Project No. 25-0056.00

October 22, 2025

ADDENDUM NO. 4
TO THE
DRAWINGS AND PROJECT MANUAL
FOR
NORTH SHORE MULTI-USE INDOOR FACILITY
GALENA PARK INDEPENDENT SCHOOL DISTRICT
HOUSTON, TEXAS

SHEET NO.
S2.01B

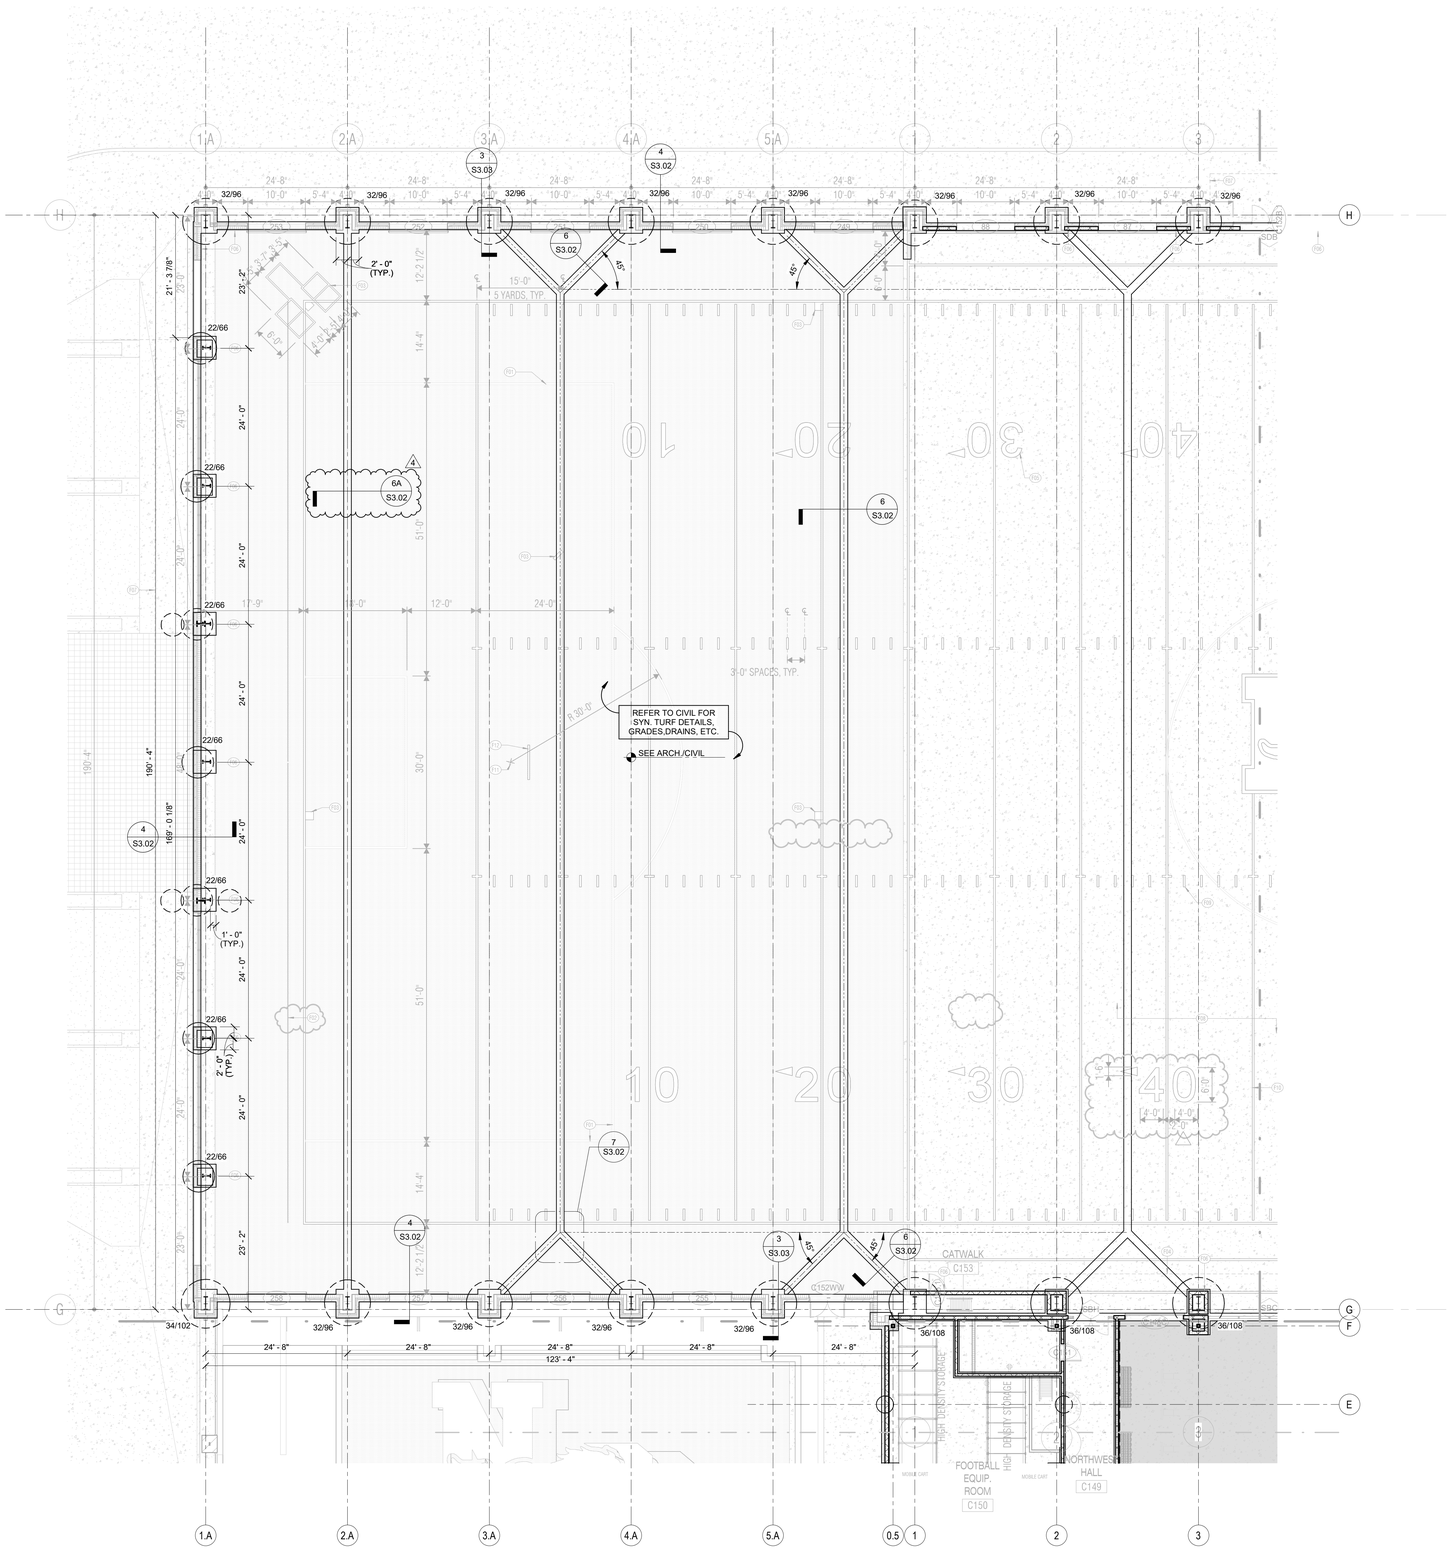
1. SHEET S2.01B– FOUNDATION PLAN UNIT B

FOUNDATION PLAN - UNIT C - ALTERNATE BID

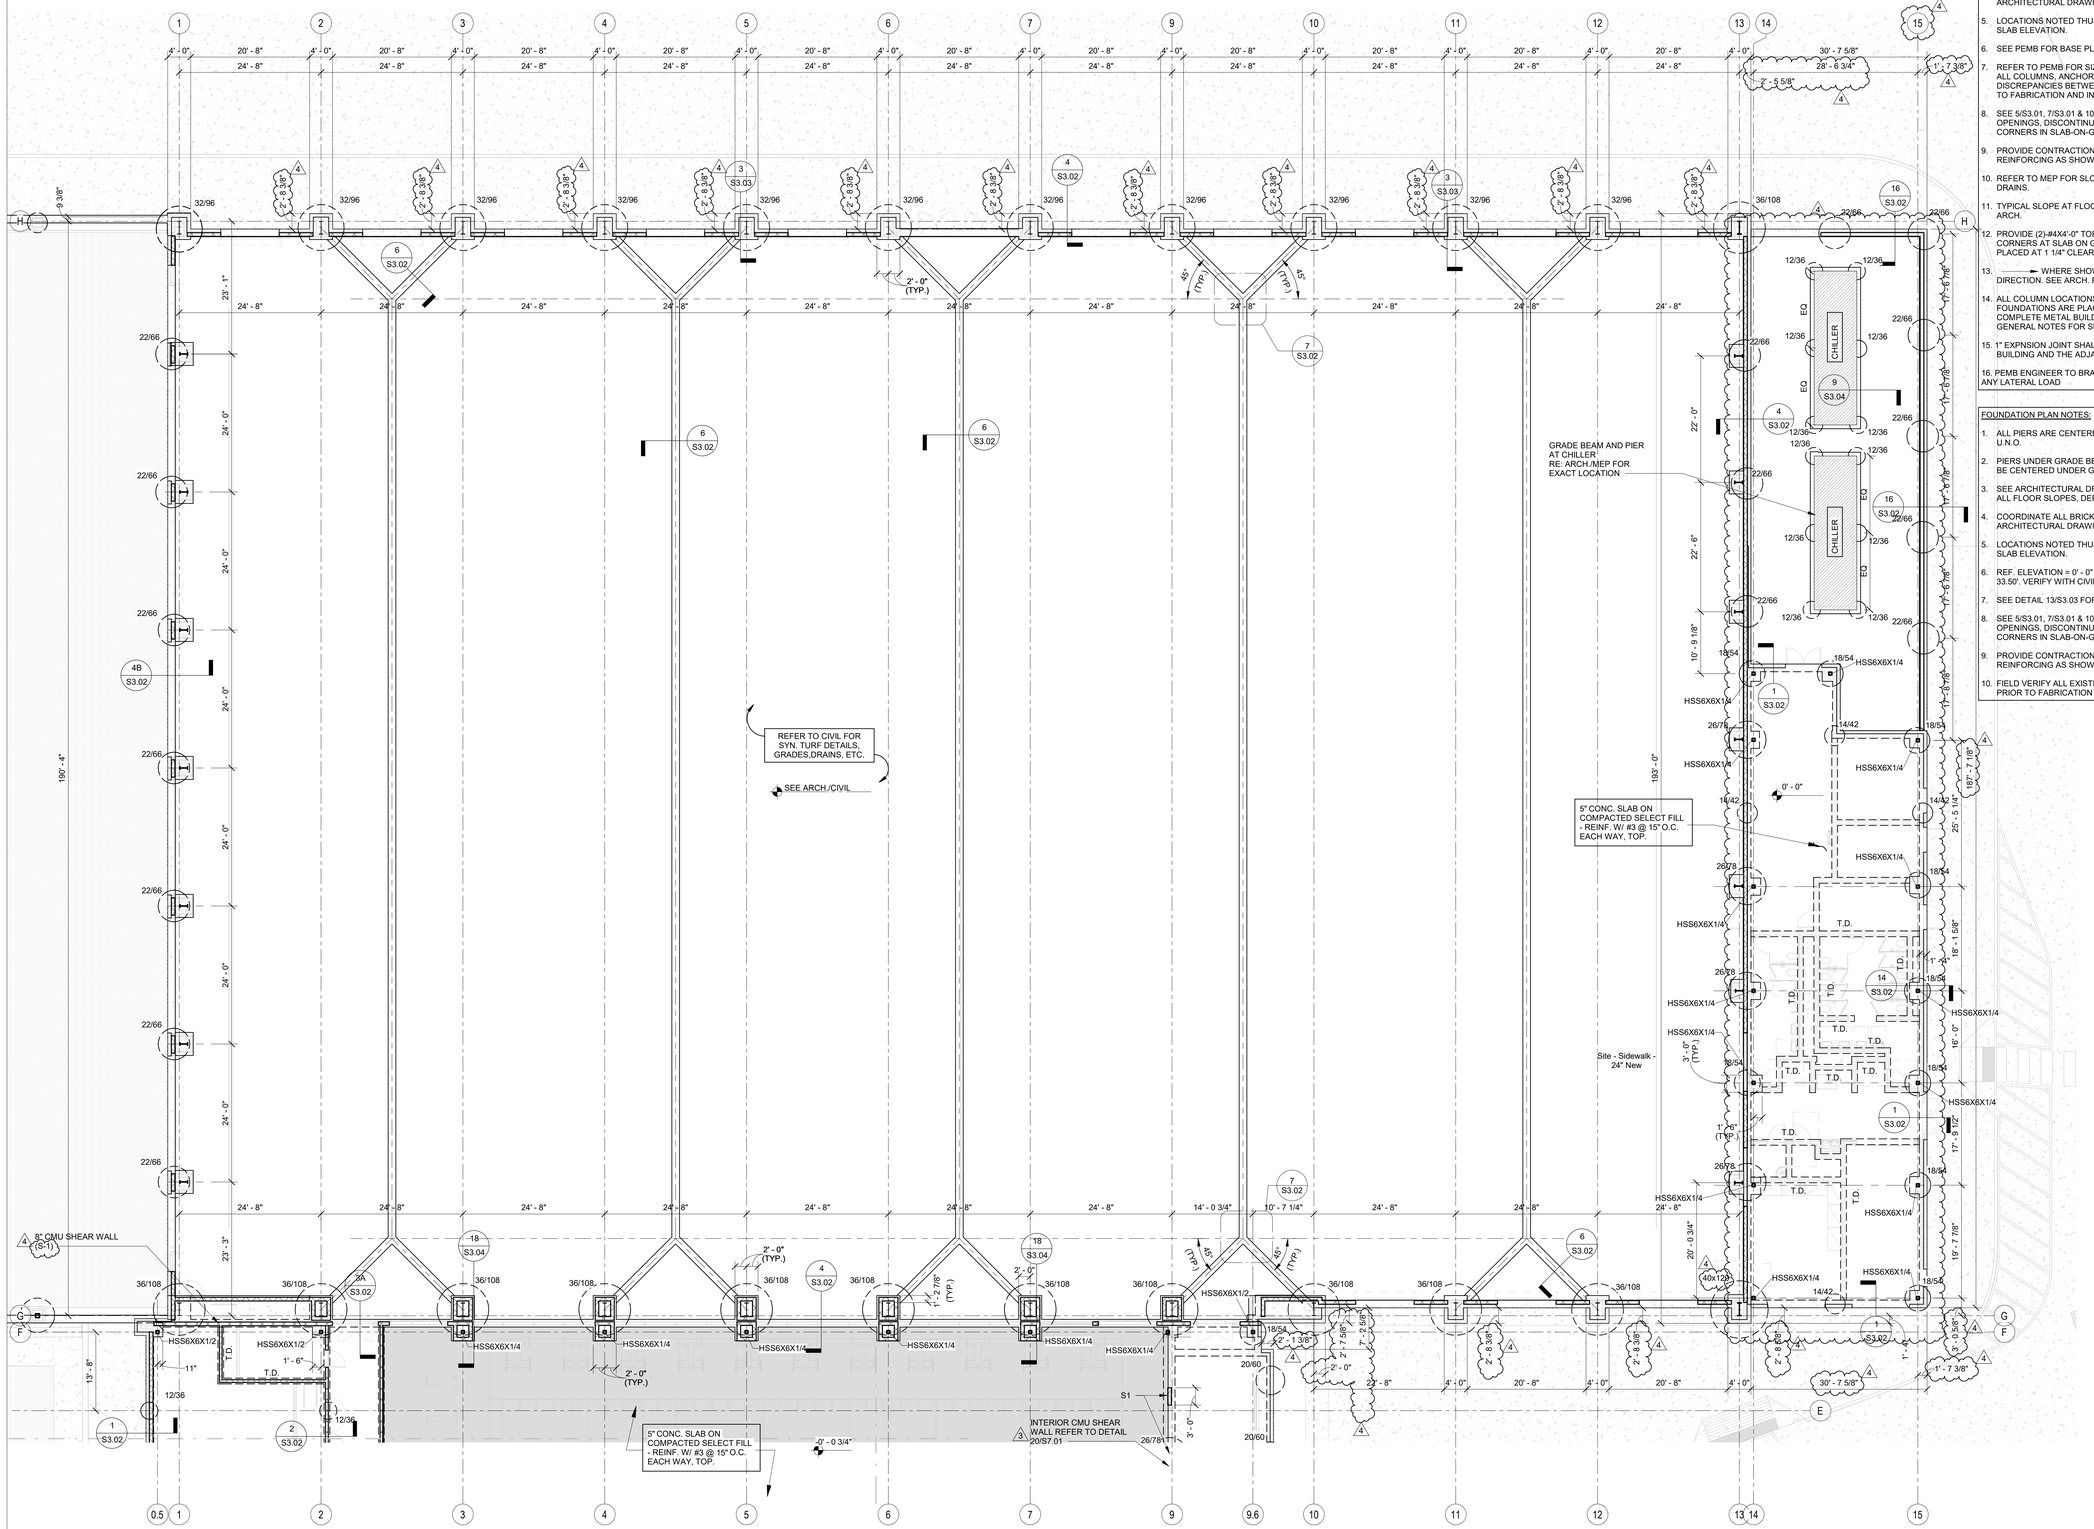
2. SHEET S2.02C.1– FOUNDATION PLAN UNIT – C – ALTERNATE BID

1 MEZZANINE FRAMING PLAN - UNIT B
SCALE: 3/32" = 1'-0"

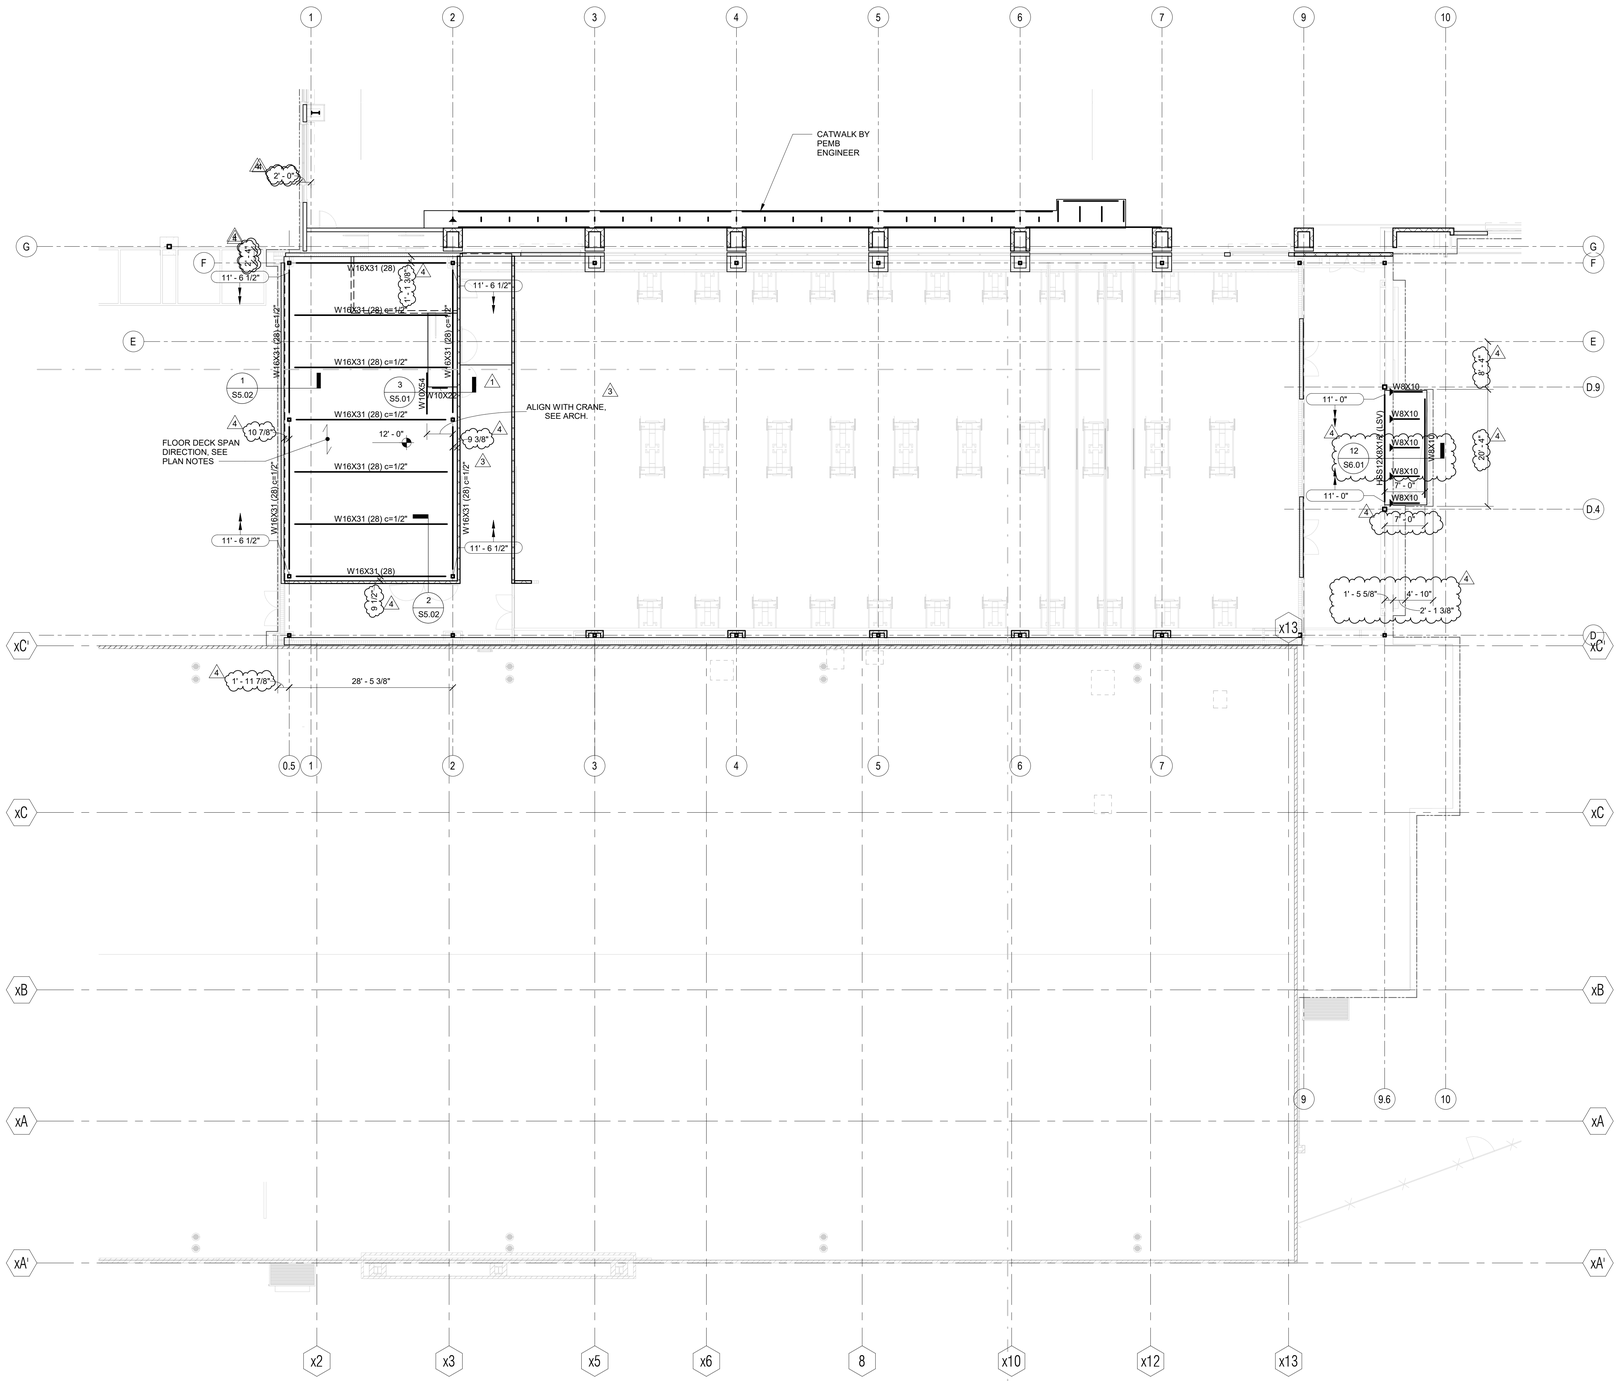
4. SHEET S2.11B – MEZZANINE FRAMING PLAN – UNIT B

1 ROOF FRAMING PLAN - UNIT B

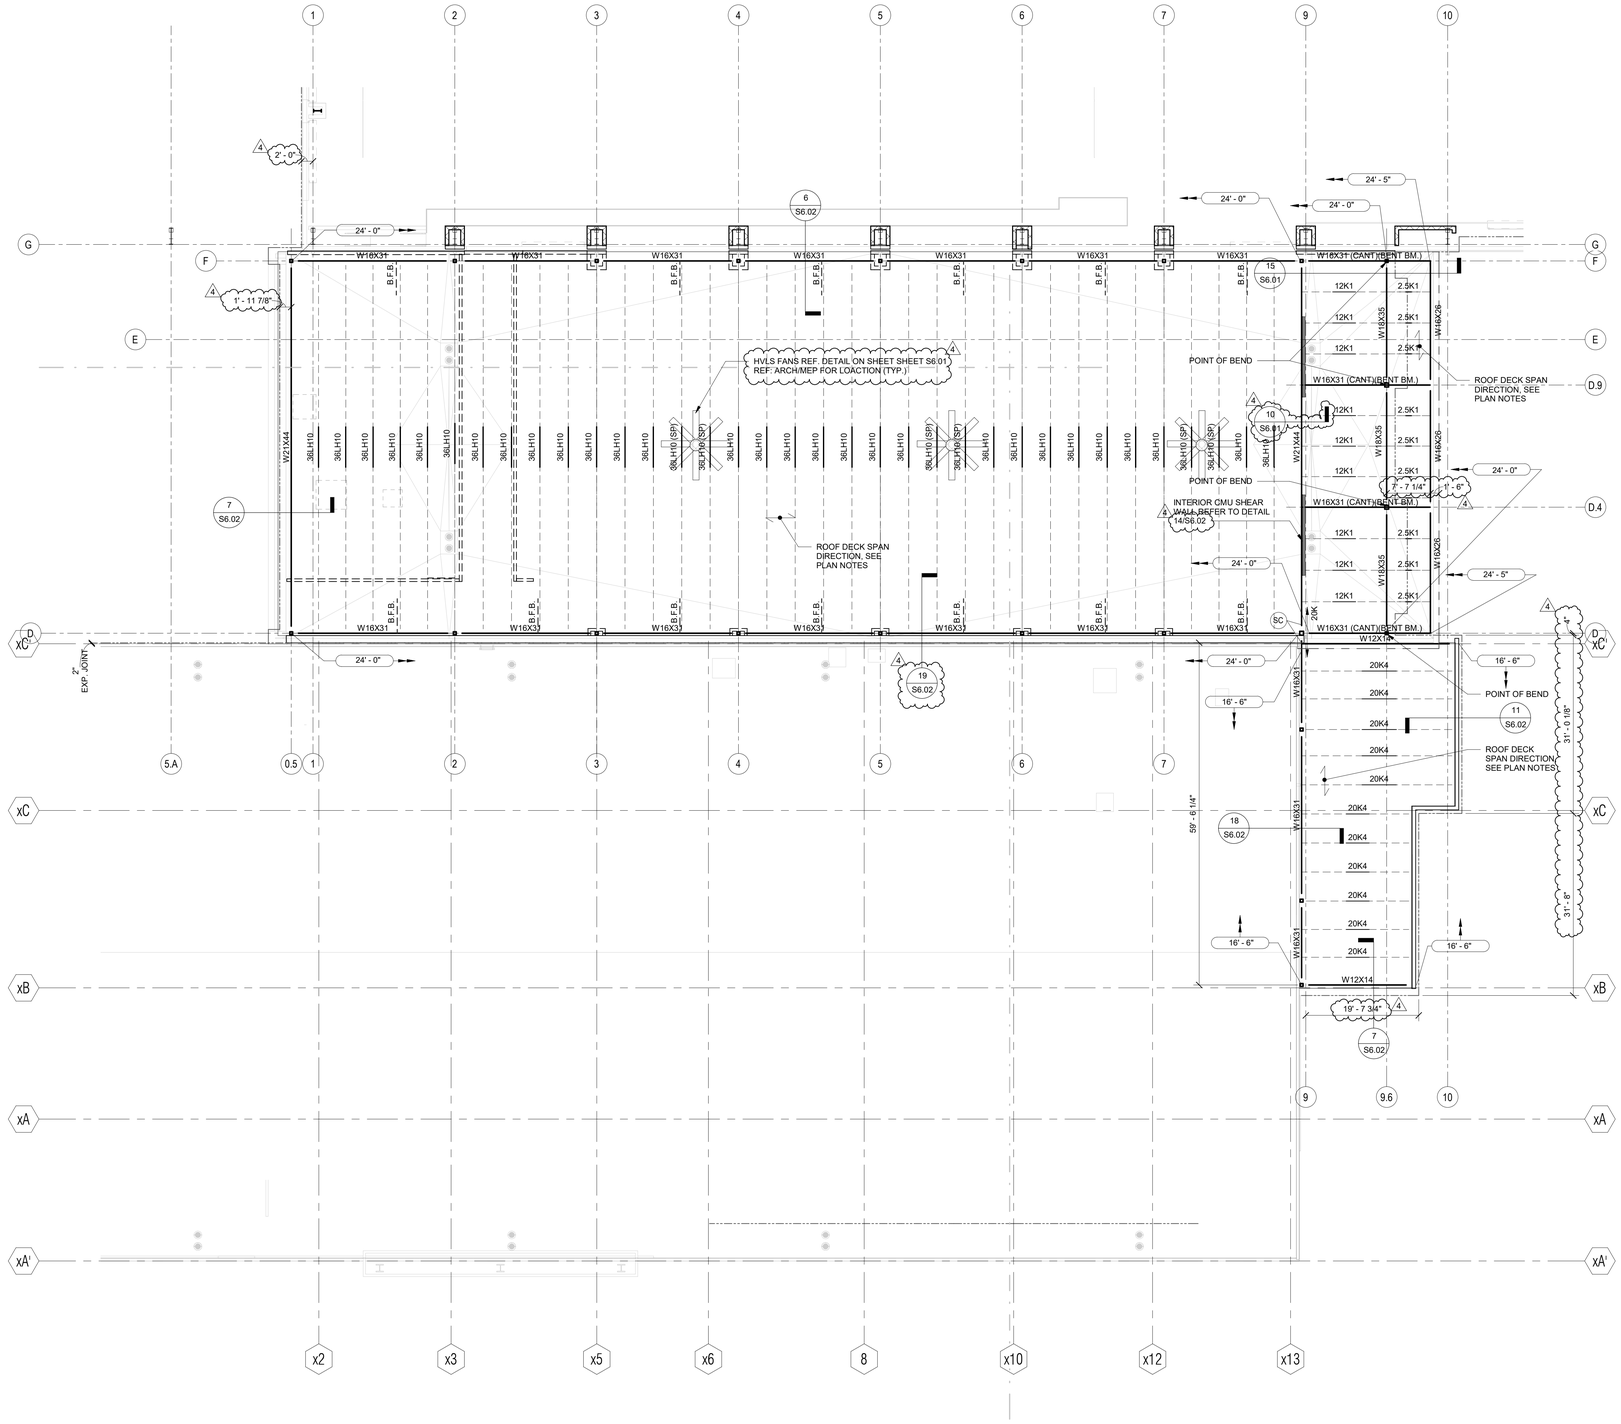
5. SHEET S2.21B – ROOF FRAMING PLAN UNIT - B
